**TOWN OF NEWBURGH
PLANNING BOARD
TECHNICAL REVIEW COMMENTS**

PROJECT NAME: ATHBOY ROAD 4-LOT SUBDIVISION
PROJECT NO.: 24-36
PROJECT LOCATION: SECTION 8, BLOCK 1, LOT 105
REVIEW DATE: 31 JULY 2025
MEETING DATE: 7 AUGUST 2025
PROJECT REPRESENTATIVE: CM TERRIZZI ENGINEERING, PLLC

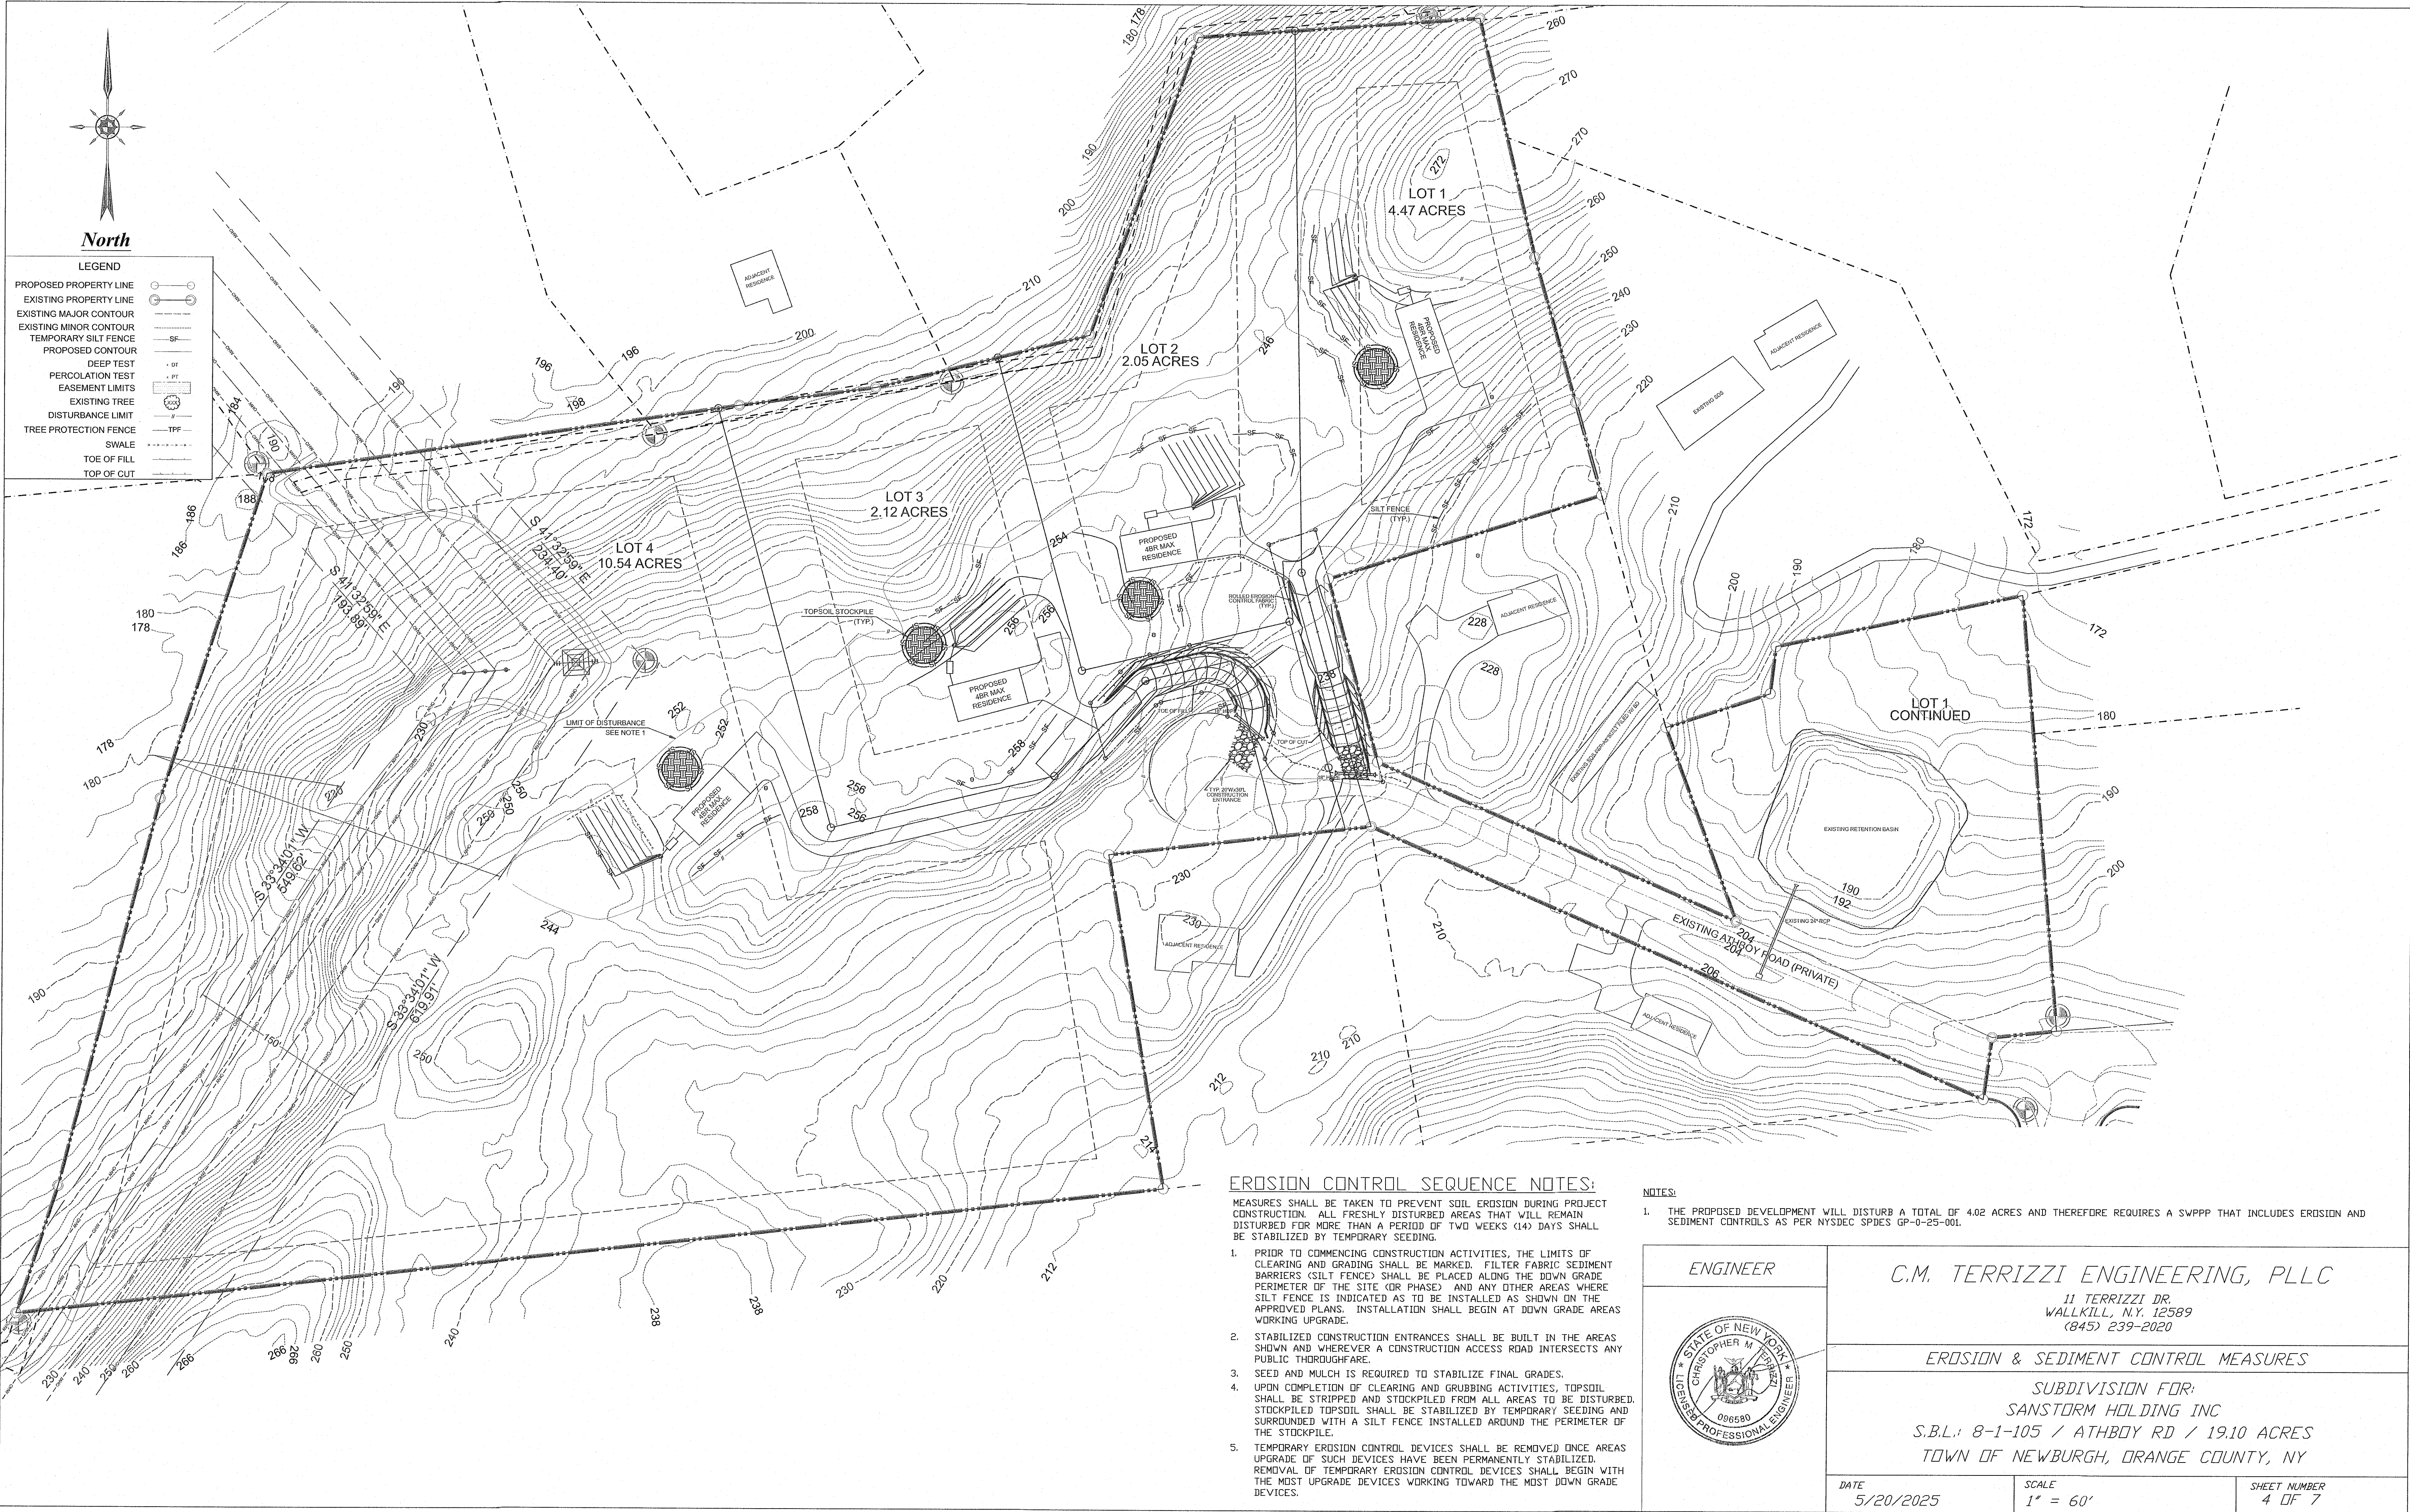
5. A SWPPP for the project has been prepared. The project is a residential project with less than 5 acres disturbance. An Erosion Sediment and Control Plan serves as the SWPPP. No water quantity or quality control or post development practices are required. Coverage under the NYSDEC Construction Stormwater Permit is required and should be a condition of any approvals.
